STATE OF MAINE
DEPARTMENT OF TRANSPORTATION
16 STATE HOUSE STATION
AUGUSTA, MAINE 04333-0016

November 18, 2022
Subject: Bridge Rehabilitation
State WIN: 021751.01
Location: **Boothbay Harbor & Southport
Amendment No. 5**

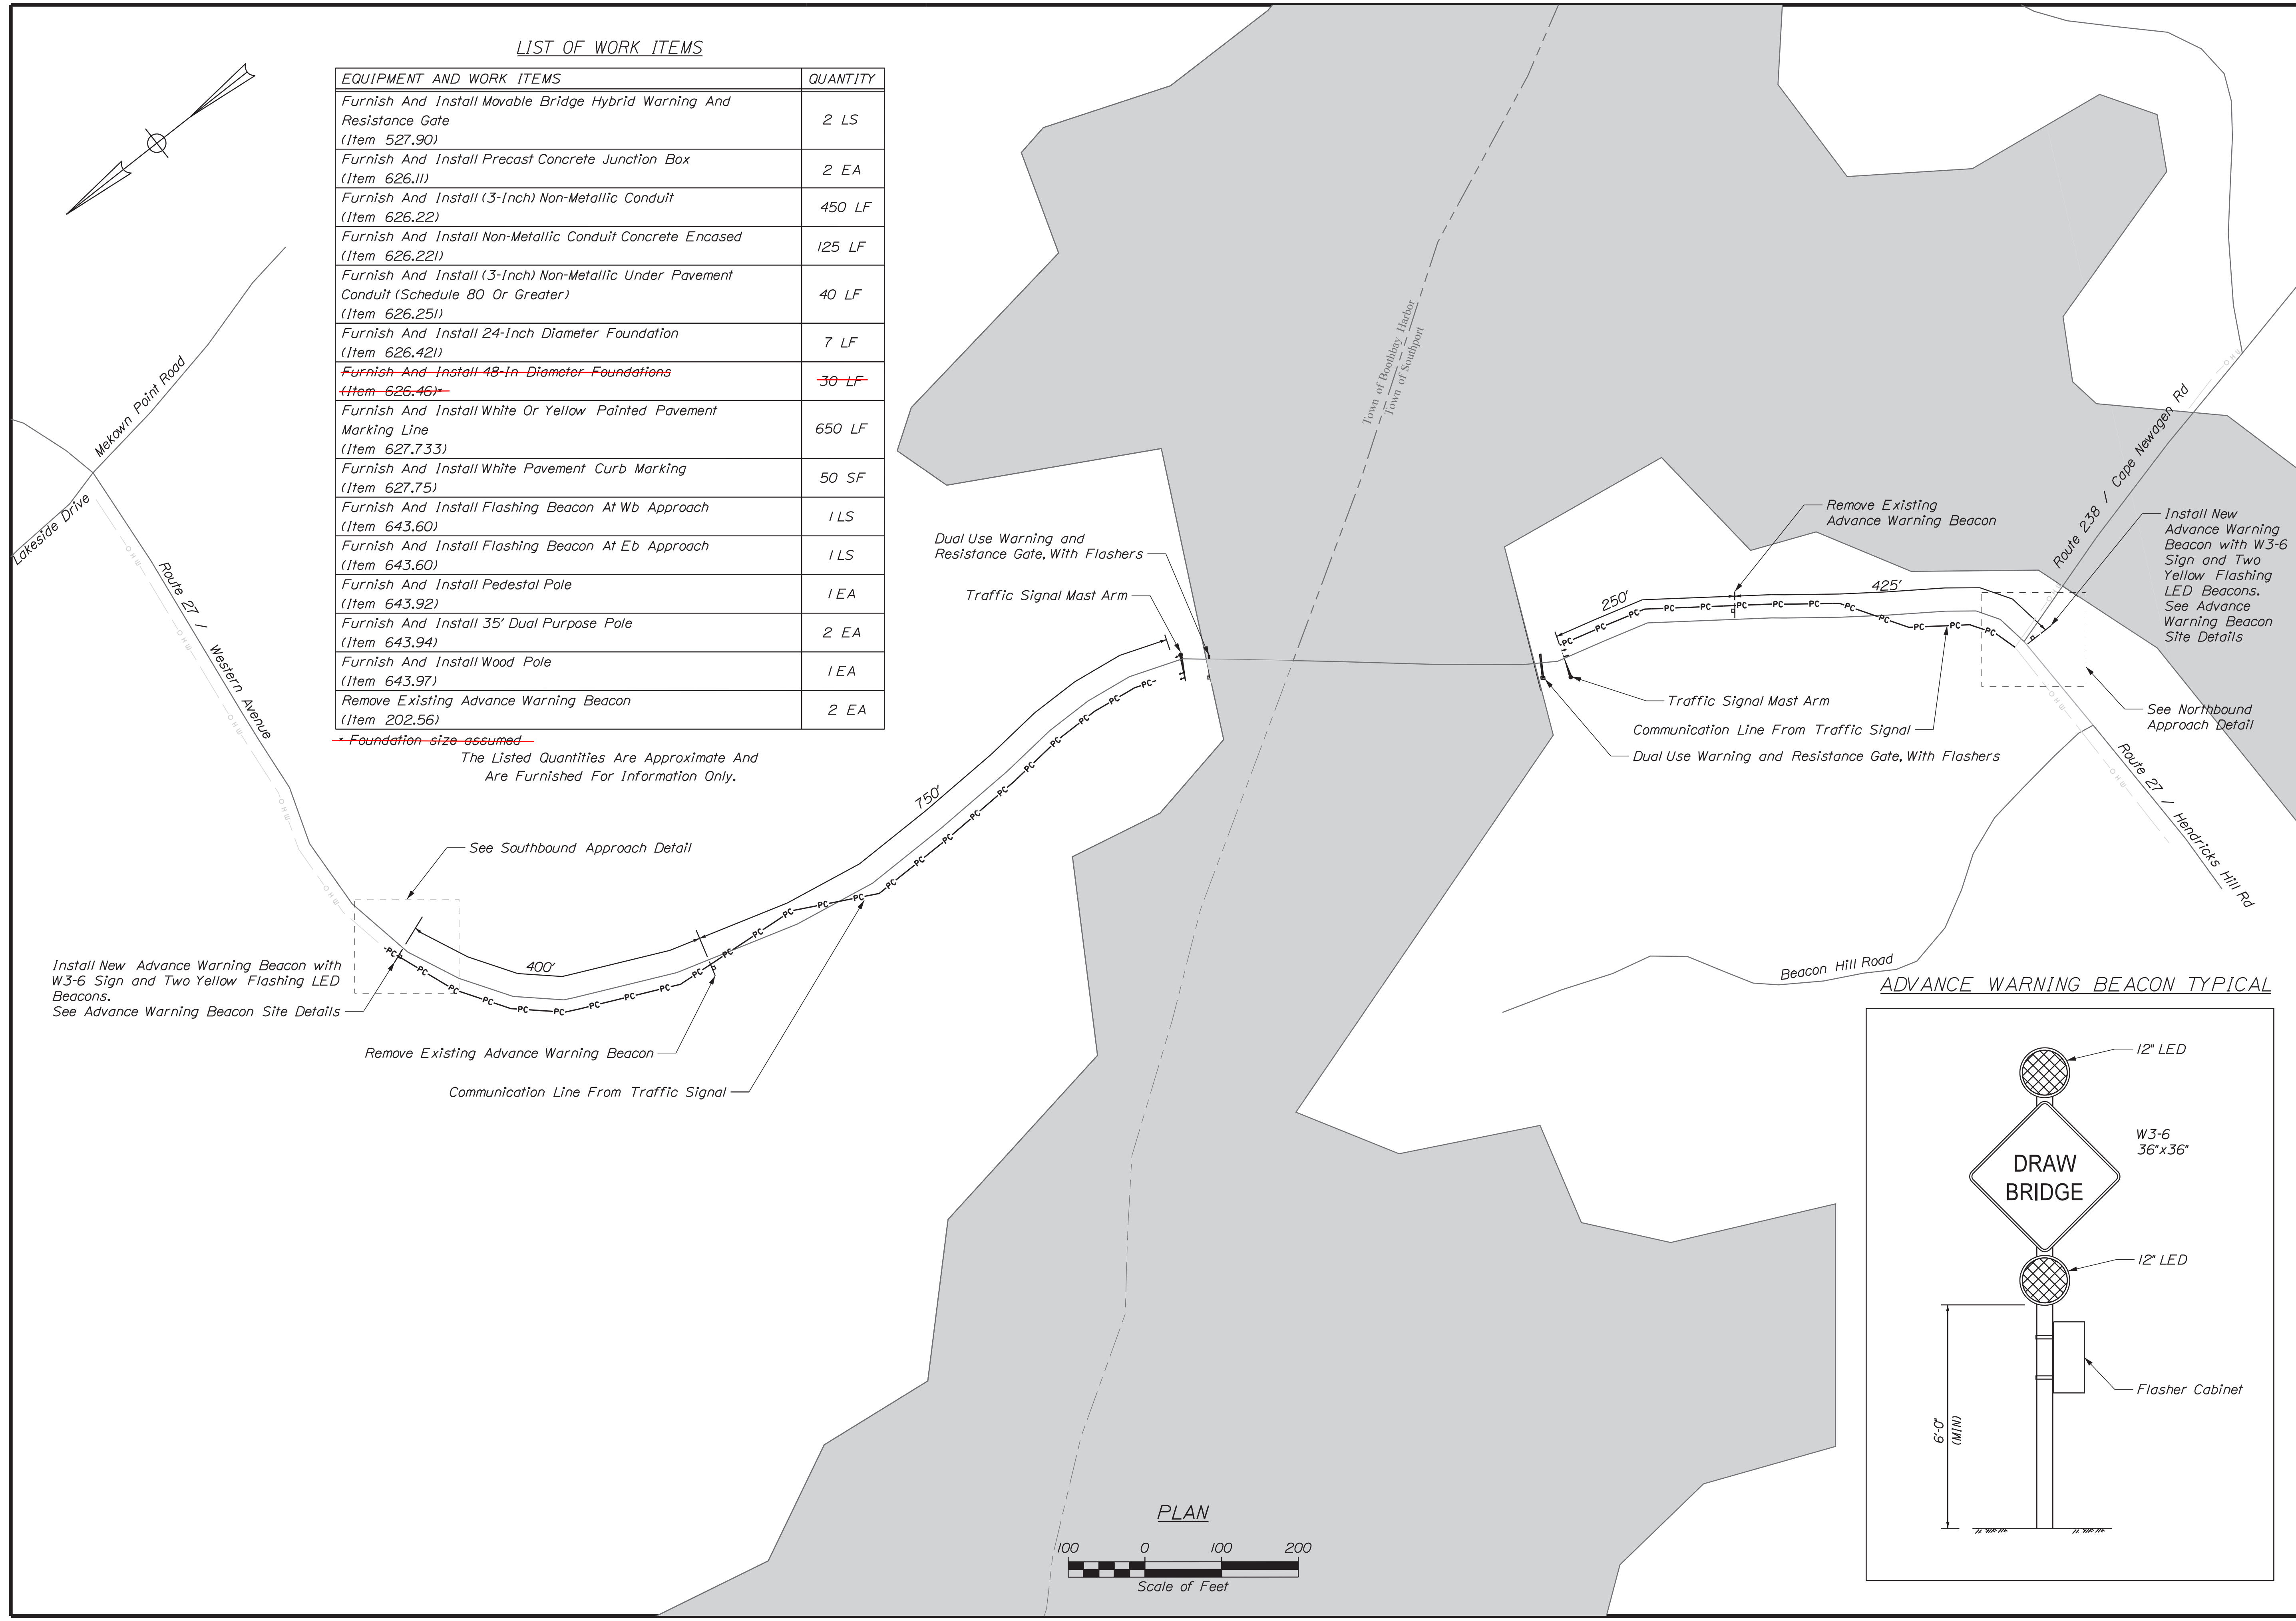
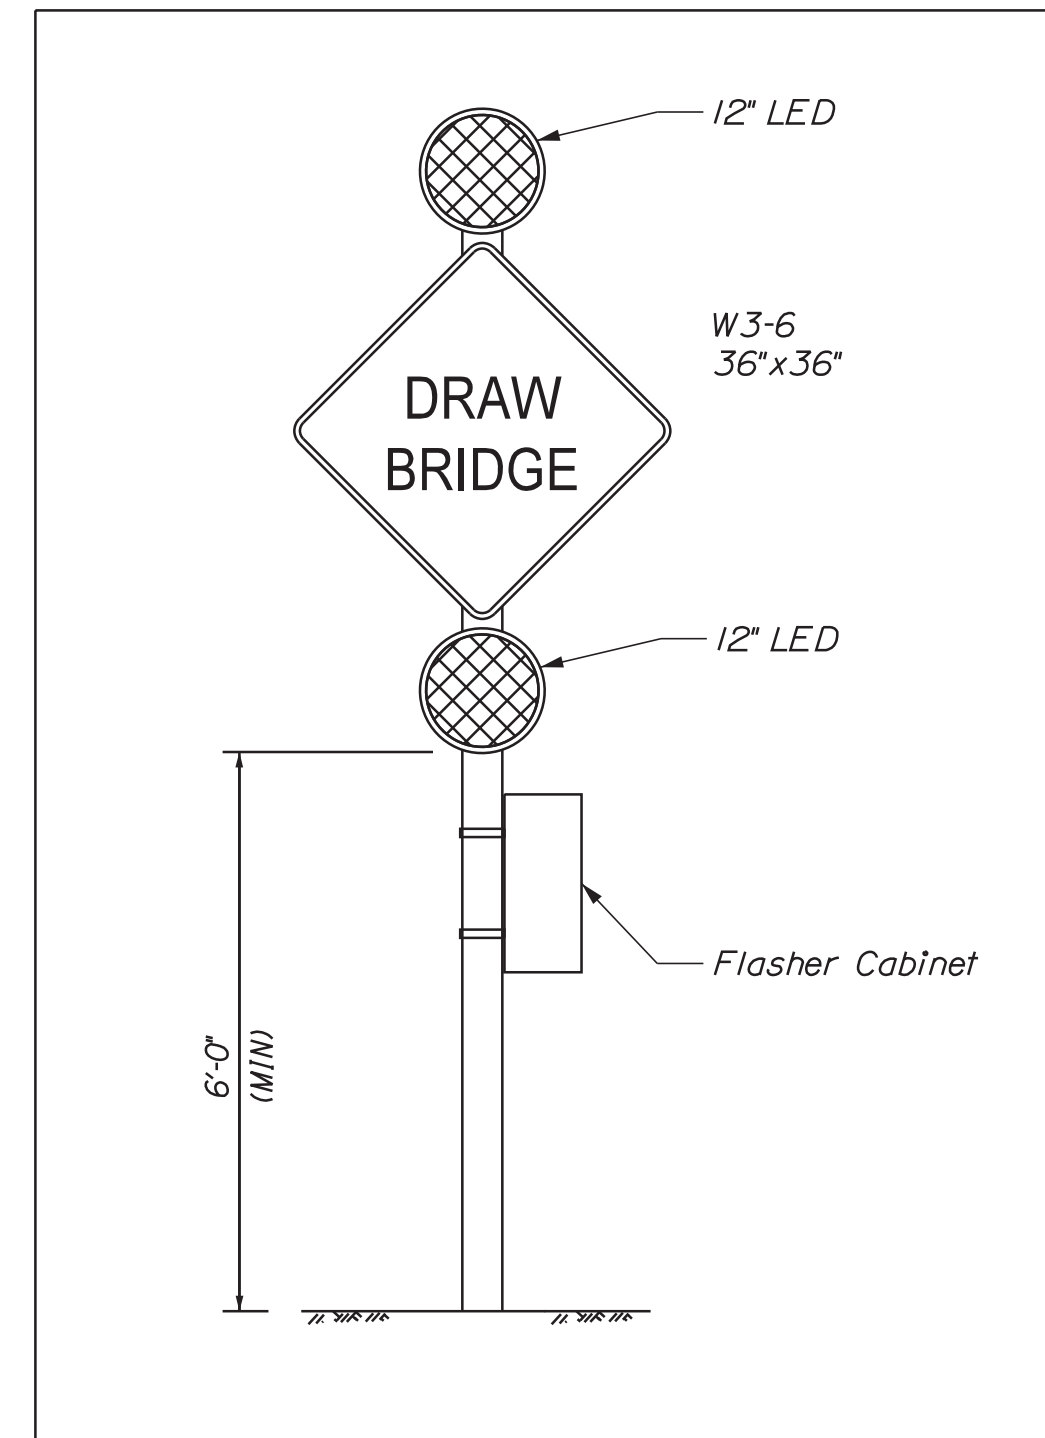
Question: Some of the pay items listed on plan sheet 45 (Advance Warning Beacon Plan) seem to be missing from the proposal schedule of items list. Can you please review these items and tell us how to proceed?

Response: Please see revised sheet number 45 of 48. Item 626.46 has been removed and Item 626.421 has been added to the Estimated Quantities on sheet 2.
